**Request for Additional Information No. 277, Supplement 3**

**U.S. EPR Standard Design Certification**

**Docket No. 52-020**

**Question 09.02.05-21:**

Figure 9.2.9-1—[[Conceptual Site-Specific Raw Water Supply System]]

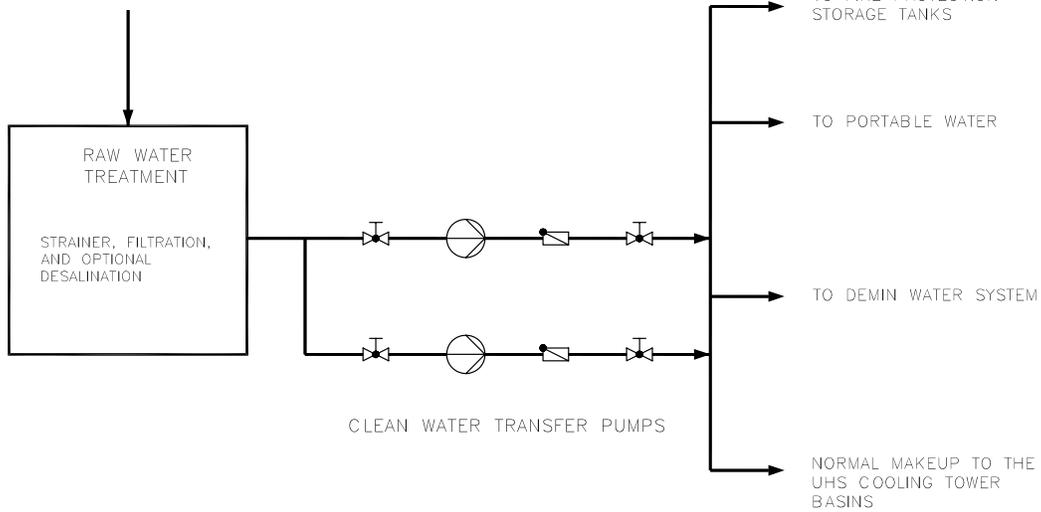
Since the design of the raw water supply system (RWSS) is not provided in the EPR design certification (DC) application, the RWSS is by definition a portion of the plant for which the application does not seek certification. Therefore, to comply with 10 CFR 52.47(a)(24), the FSAR needs to be revised to include a conceptual design for the RWSS. Also, to comply with 10 CFR 52.47(a)(25), the FSAR, including Chapter 4, "Interface Requirements," of Tier 1, needs to be revised to include sufficiently detailed interface requirements for the RWSS that must be satisfied by combined license applicants when they provide their plant specific RWSS design.

Since the plant specific RWSS will be needed to replenish the UHS basin post 72 hours, the plant specific RWSS will need to be safety-related and the staff will need to review the EPR DC interface requirements to ensure that the plant specific RWSS design will be capable of performing its safety-related makeup function.

U.S. EPR FSAR Tier 2, Section 9.2.9 will be revised to describe a conceptual design for the non-safety-related RWSS and will reflect a new figure showing the conceptual site-specific RWSS.

[[The RWSS contains water received from a site-specific natural source and supplies it directly to the points of use where it may be further processed by the receiving plant systems. The raw water for demineralized water, potable water, fire protection, and ultimate heat sink (UHS) normal makeup is preprocessed as required by filtration, reverse osmosis, chemical treatment, and desalinization of brackish raw water sources prior to use.]] The conceptual design of the RWSS is shown in Figure 9.2.9-1—[[Conceptual Site-Specific Raw Water Supply System]].
